SERVICE BULLETIN

EC20-020

NTB20-094

2015-2020 ROGUE; MIL ON WITH DTC P0181 AND/OR P0183

Figure 1

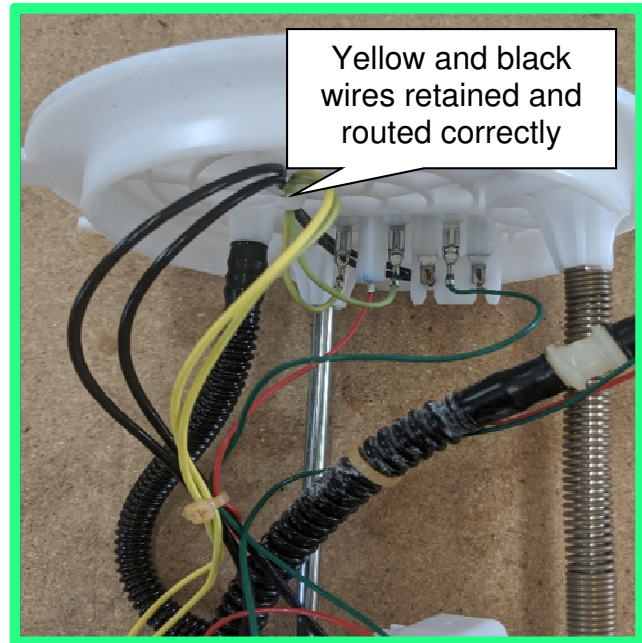
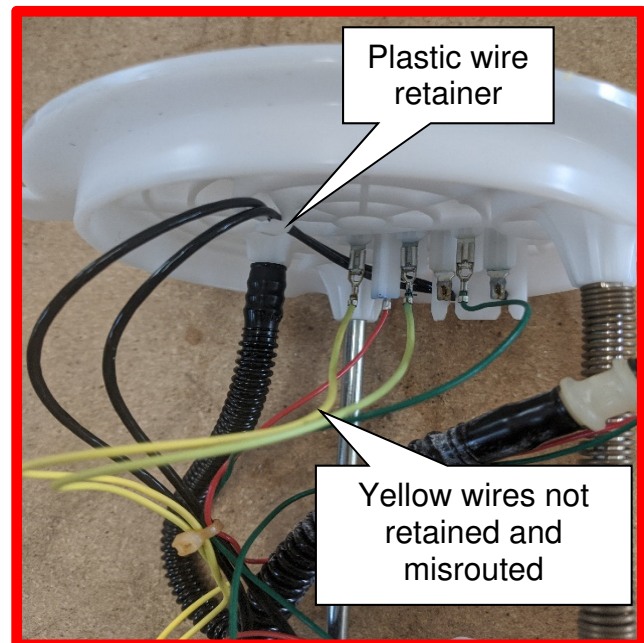
The MIL is ON with DTC P0181 (FTT SENSOR) and/or P0183 (FTT SEN/CIRCUIT) stored in the ECM.

2. Inspect the routing of the yellow wires on the fuel pump assembly. The yellow and black wires should be routed the same way and retained at the top by the plastic wire retainer as shown in Figure 1.
 - If the wires are routed correctly, continue to step 3.
 - If the wires are not routed correctly, as shown in Figure 2, route them as shown in Figure 1.

1. Remove the fuel pump assembly.
2. Inspect the fuel pump assembly wiring, and reroute the wiring, if applicable.
3. Reinstall the fuel pump assembly.
